COMMENTS ON DRAFT EIS AND BLM RESPONSES

RE: Draft Environmental Impact Statement Buckskin Hay Creek II Coal Lease Application

Thank you for this opportunity to comment on the Draft Environmental Impact Statement for the Buckskin Mine Hay Creek II Coal Lease Application (WYW-172-684). As always, we appreciate the tremendous amount of work that has gone into the DEIS, but still feel that key issues have been glossed over or ignored. Adequacy of environmental impact statements is not determined by the number of pages, but by the accuracy and clarity of the analysis.

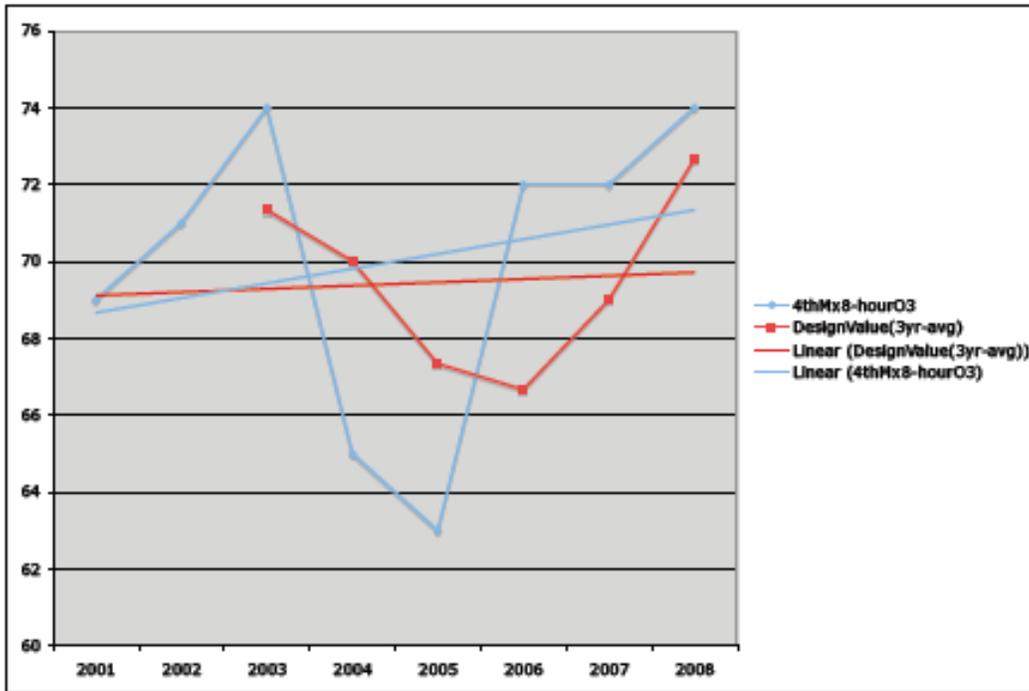
The DEIS fails to adequately analyze and assess ozone impacts to ensure compliance with the NAAQS.

The BLM mistakenly asserting that the new ozone NAAQS of 0.075 ppm is not applied retroactively. *See* DEIS at 3-61—3-62. In other words, the agency is asserting that prior to May 2008, when the new ozone NAAQS was promulgated, impacts and compliance are assessed in the context of the old ozone NAAQS of 0.080 ppm. As a result, BLM does not seem to be addressing exceedances of the current NAAQS that occurred prior to 2008 in the context of analyzing and assessing impacts, and that bear on the status of air quality in the region.

**4<sup>th</sup> Maximum 8-hour Ozone Readings and Ozone Design Values (three year average of 4<sup>th</sup> max.) from Thunder Basin Ozone Monitor (above) and S. Campbell County Ozone Monitor (below) (data from EPA).**

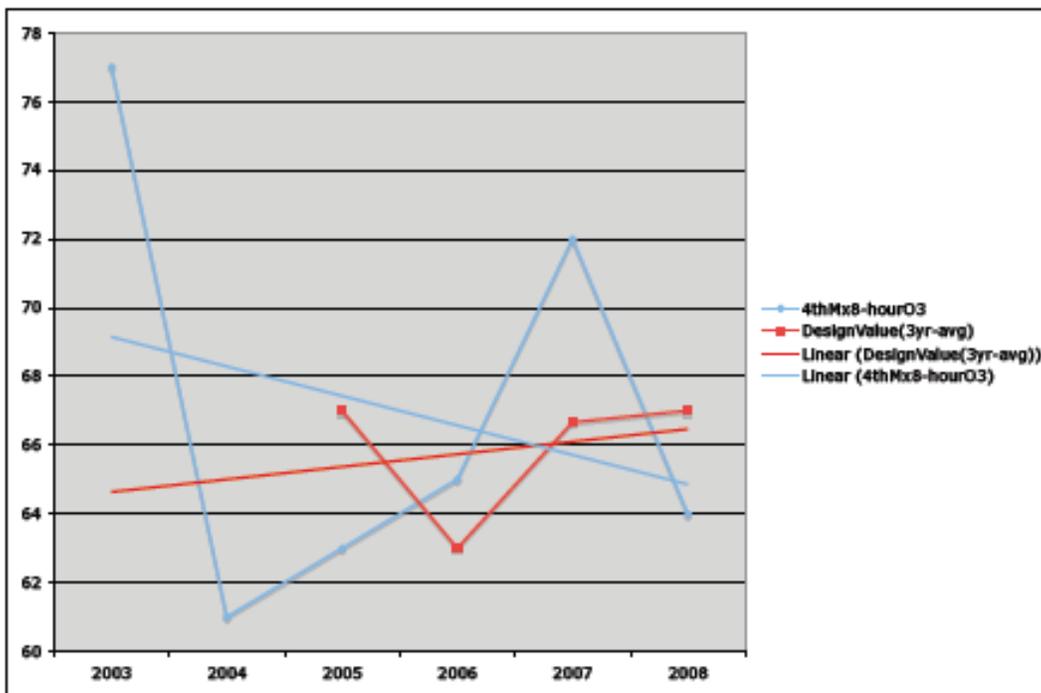
<sup>22</sup> *See Exhibit 6.* Contrary to BLM’s assertion, an exceedance of the ozone NAAQS occurs anytime 8-hour concentrations exceed 0.075 parts per million. This is why the EPA monitoring data identifies 16 ozone exceedances at the Campbell County ozone monitors since 2001.

The DEIS does not quantitatively analyze impacts to the current ozone standards. While the DEIS recognizes ozone as a harmful air pollutant, there is no actual analysis of impacts to ambient ozone concentrations. This is of particular concern given the state of air quality in the Powder River Basin. The current design value at the Thunder Basin monitor in Campbell County is 0.072 ppm—96% of the NAAQS. This is the highest the design value has been since the monitor went online in 2001.

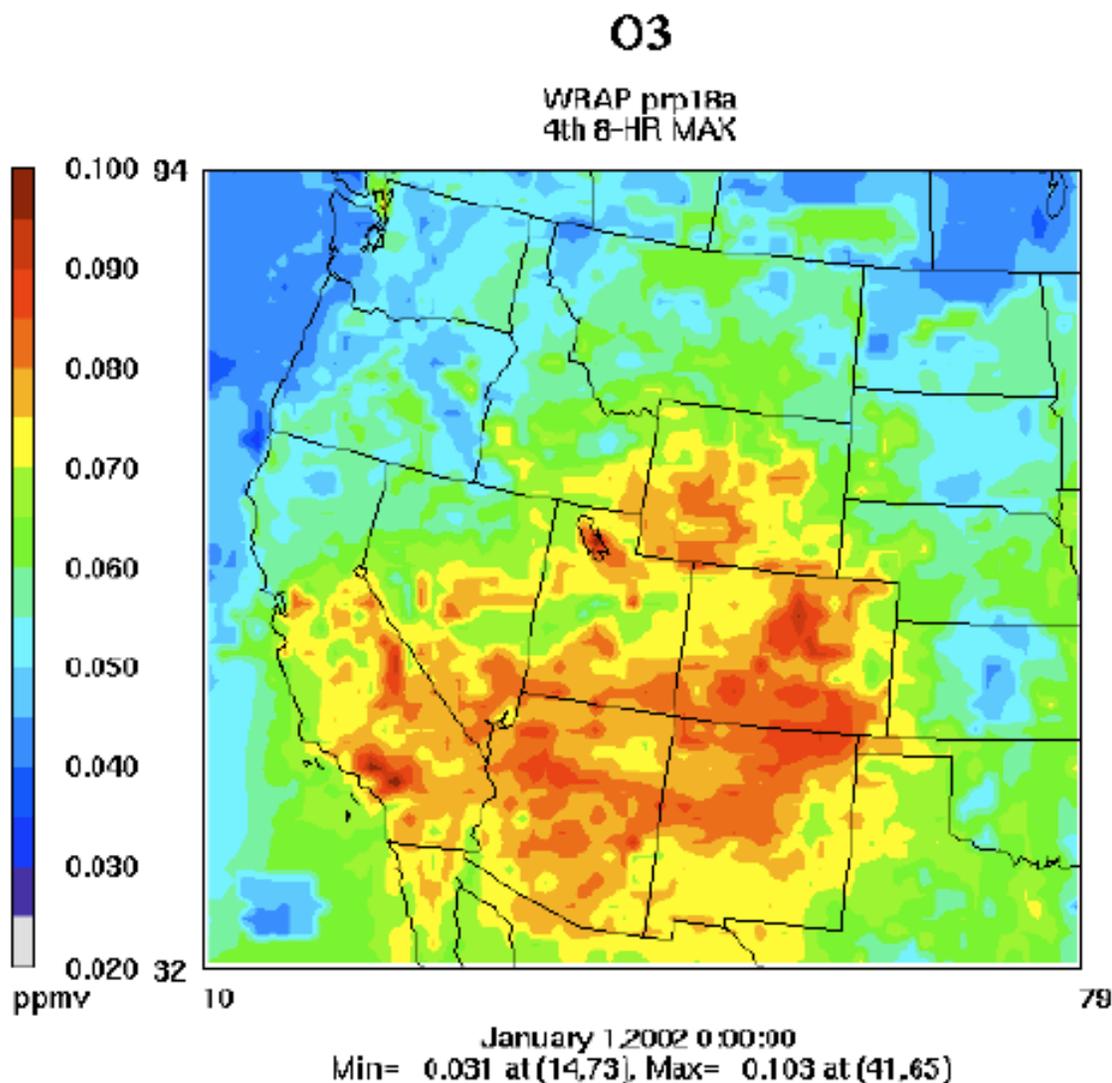
Also of concern is that the DEIS fails to address the results of modeling prepared for the Western Regional Air Partnership, which strongly indicate that attainment and maintenance of the 8-hour ozone NAAQS is at risk throughout the Western States, including in the Powder River Basin of Wyoming.<sup>25</sup> This modeling in fact shows that the annual fourth maximum 8-hour ozone concentration will exceed 0.075 ppm throughout much of Wyoming. *See* Figure below.
